**Project Name:** \* Bridge 9 over South River on US 13

B-4635

Subject: **Request for Additional Information for T.I.P. B-4635 (Replacement of Bridge 9 over South River Overflow on US 13, Sampson County)**

NAD 83/2011

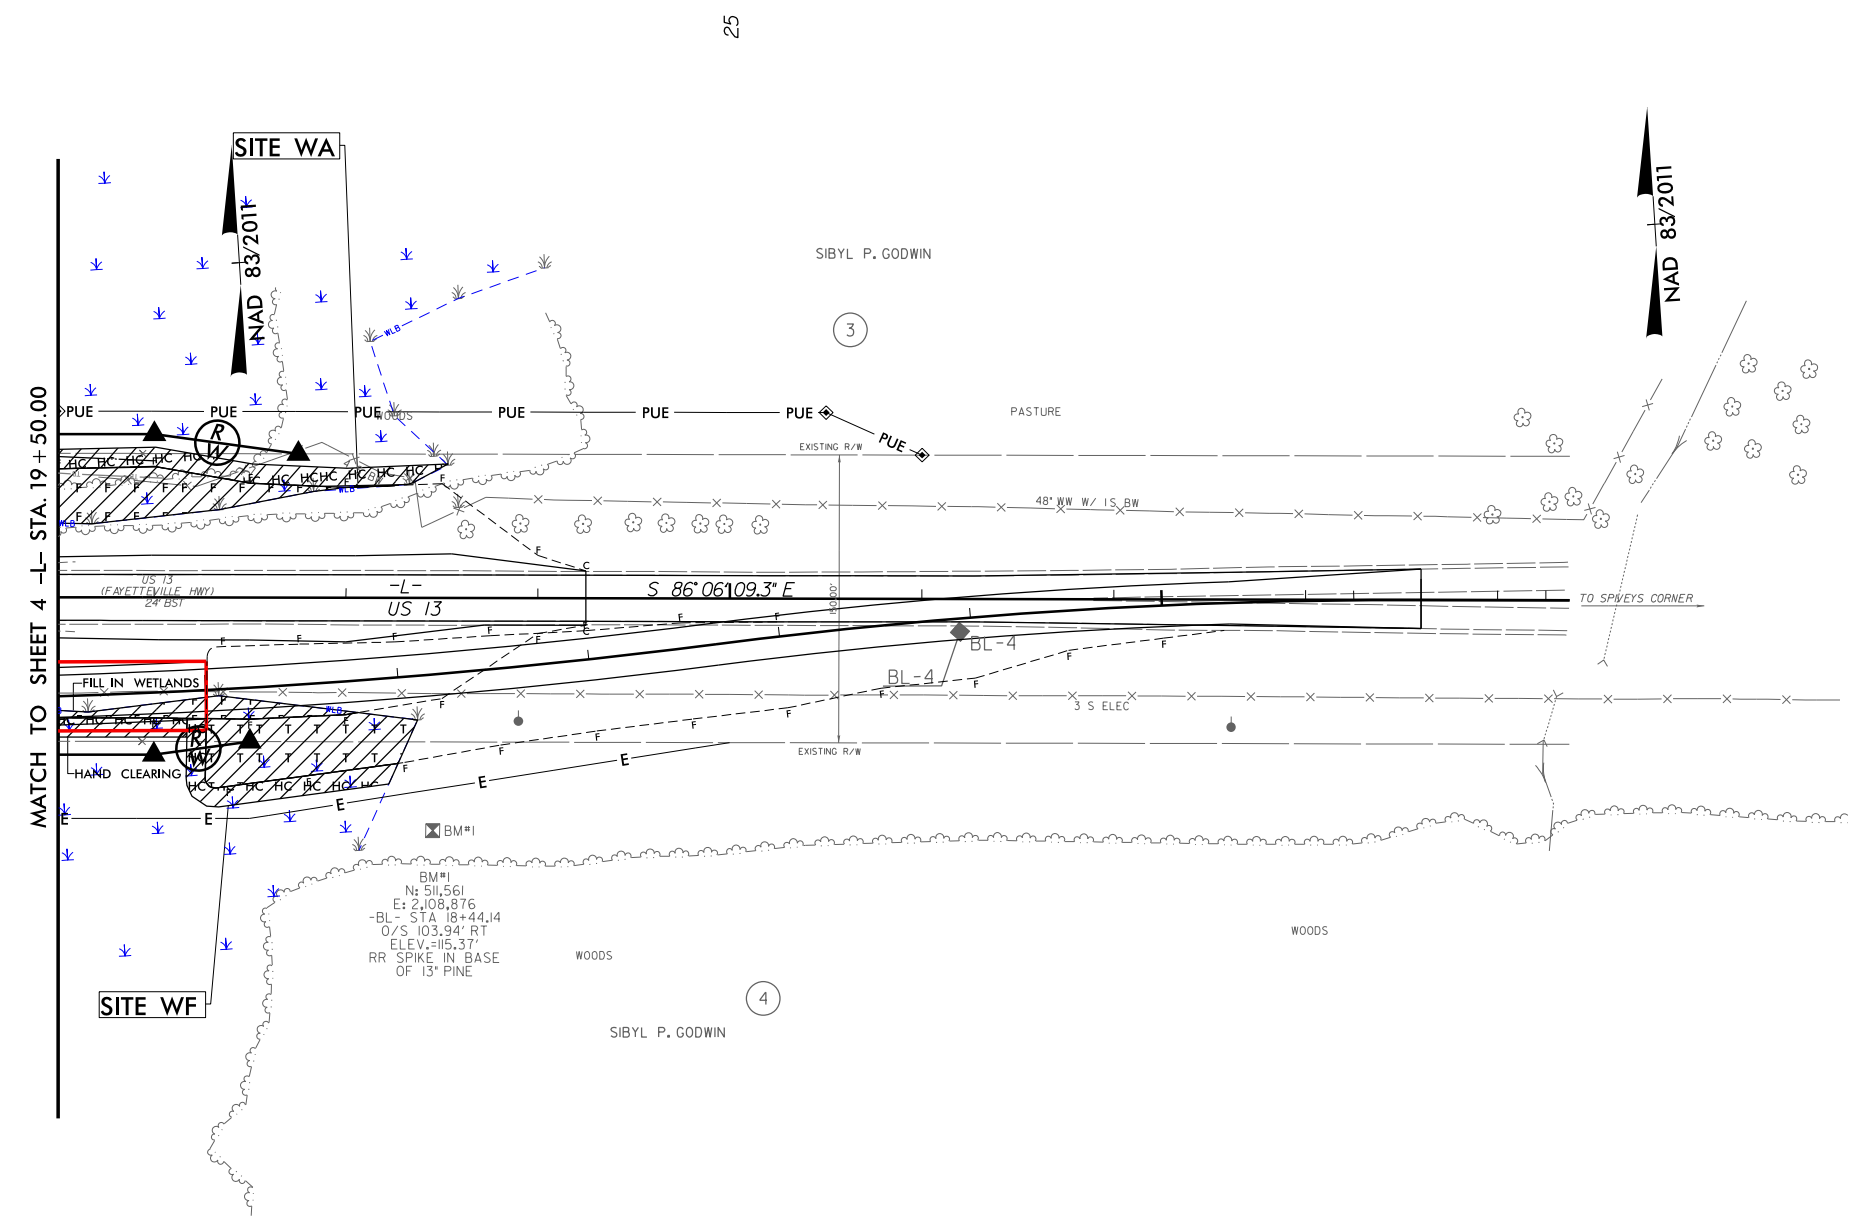
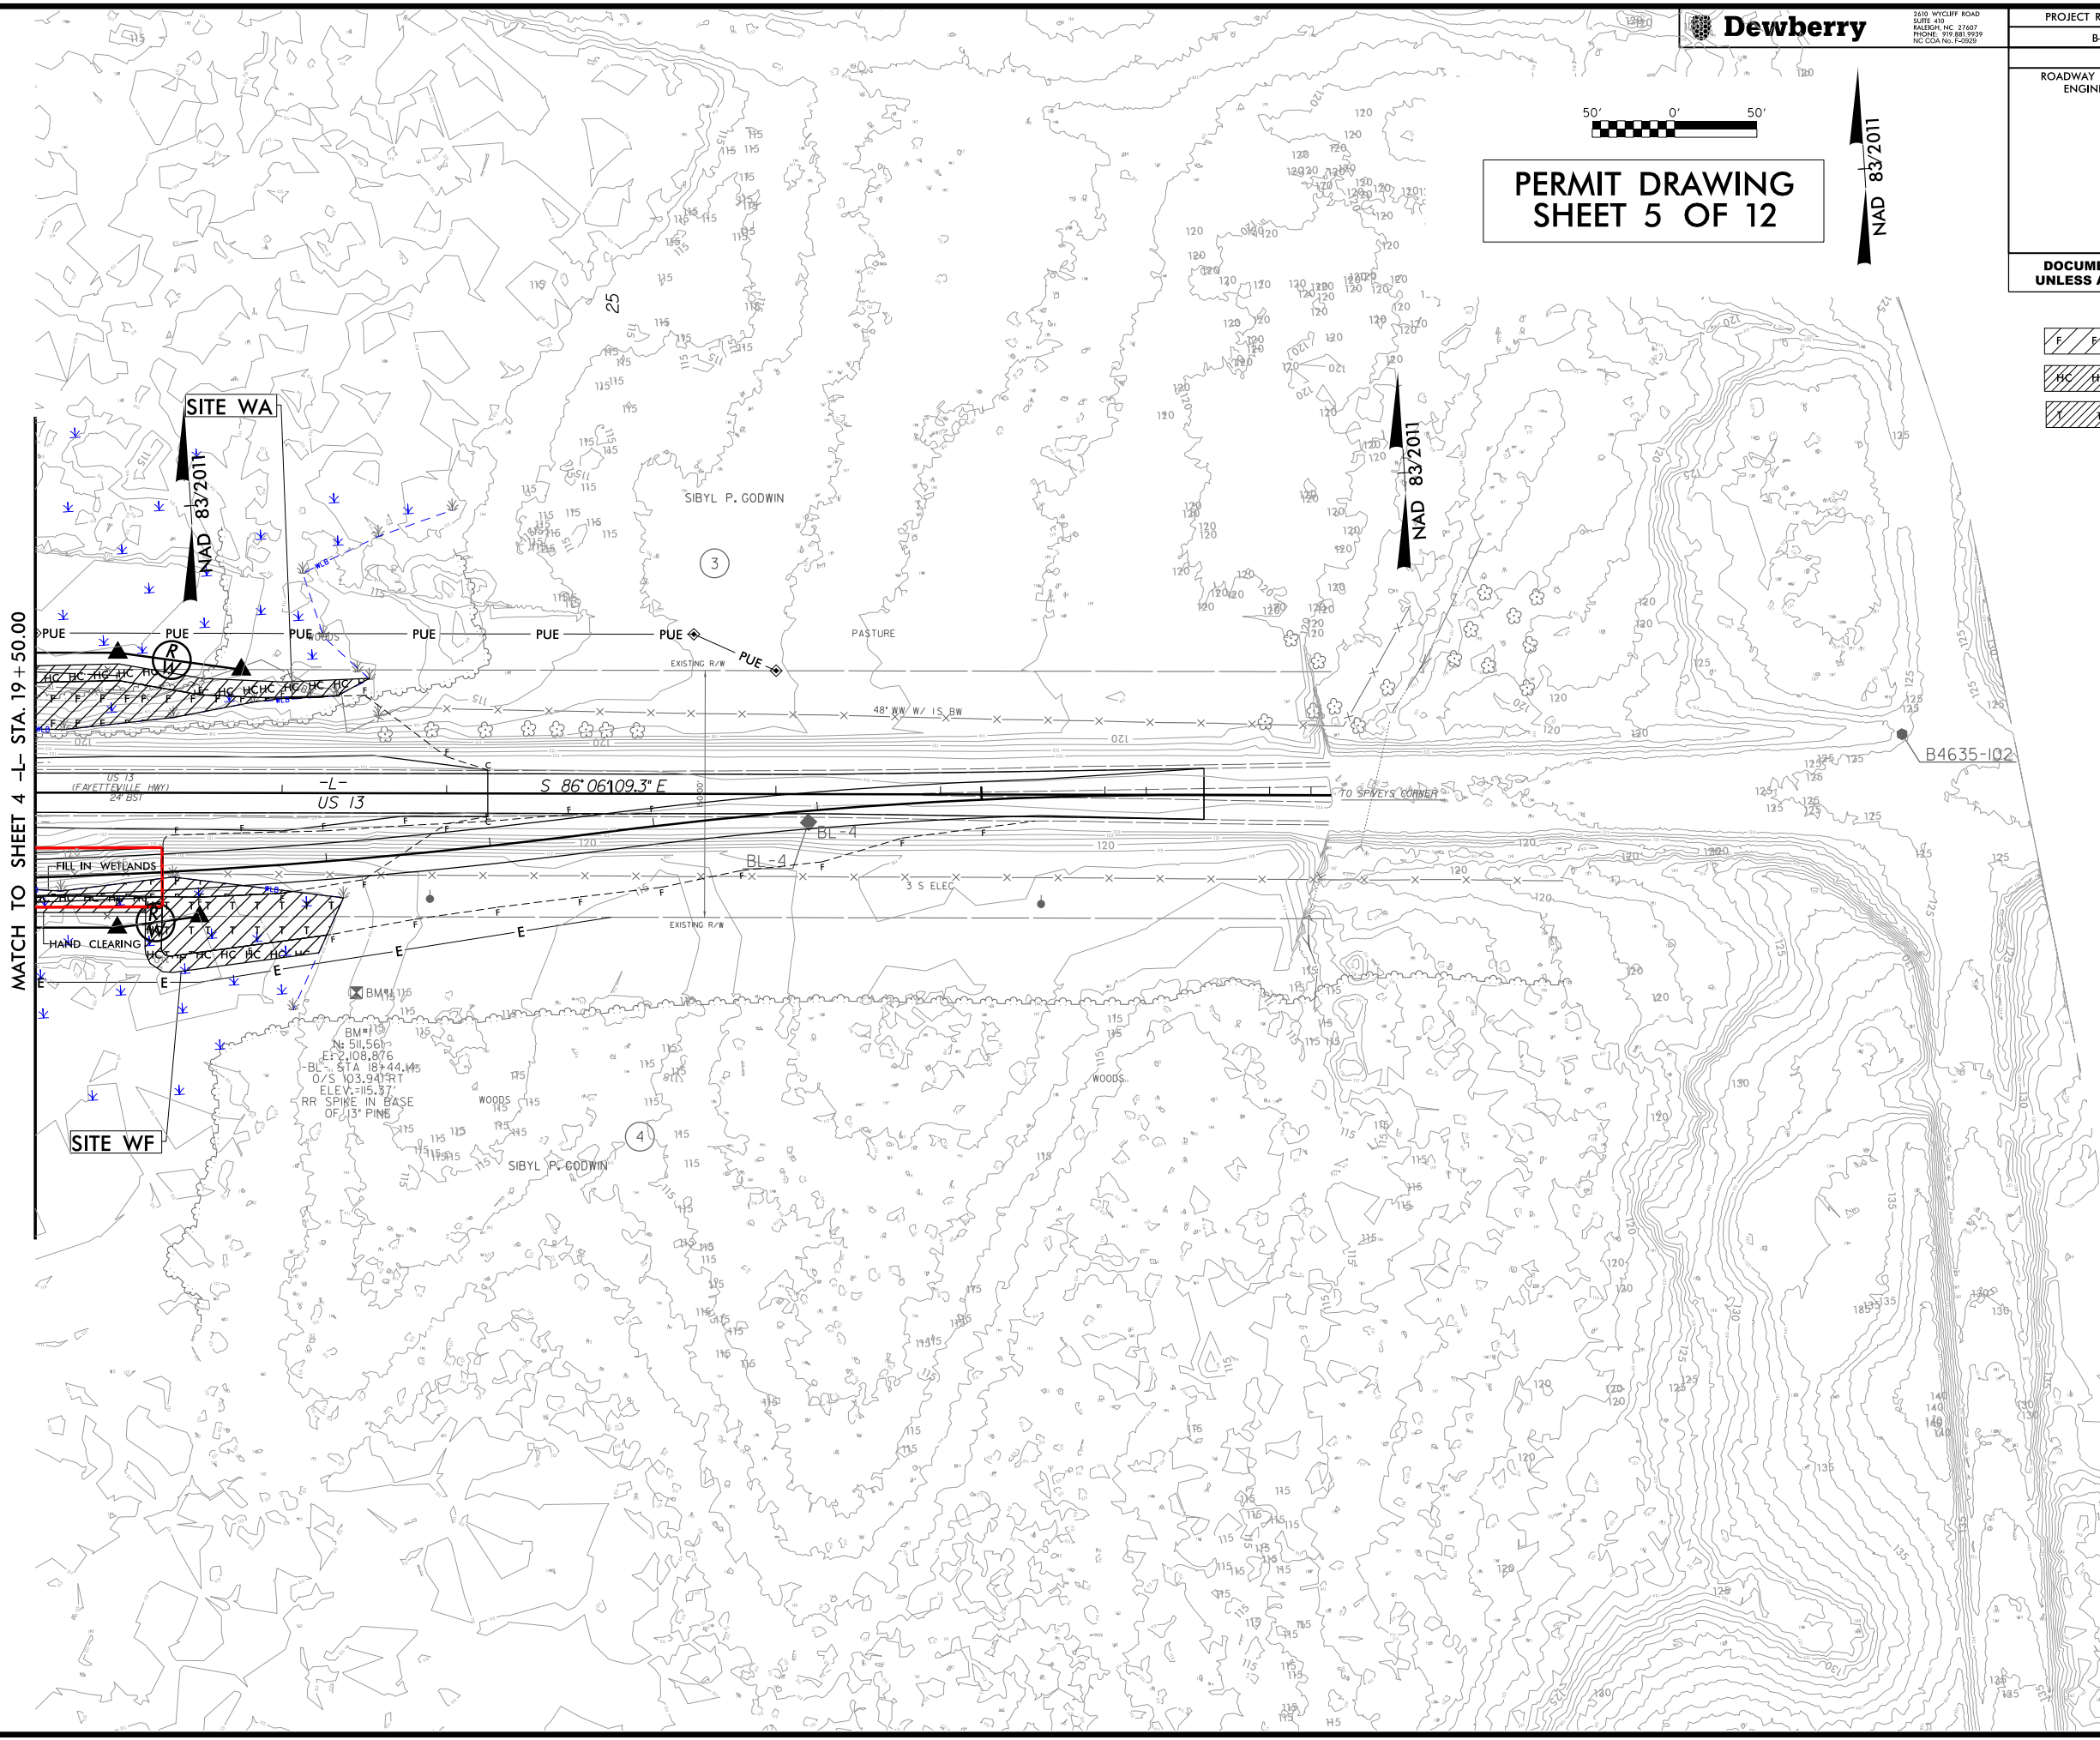
- along the north side of the project where permanent fill is called for HC is noted. Within Division 3, MC has always been requested along the slopes of permanent fill. This has been confirmed with Division please correct throughout the package. If less than 10' of fill 5' of MC is appropriate and greater than a 10' fill height 10' has been the standard. **Permit drawings have been revised.**
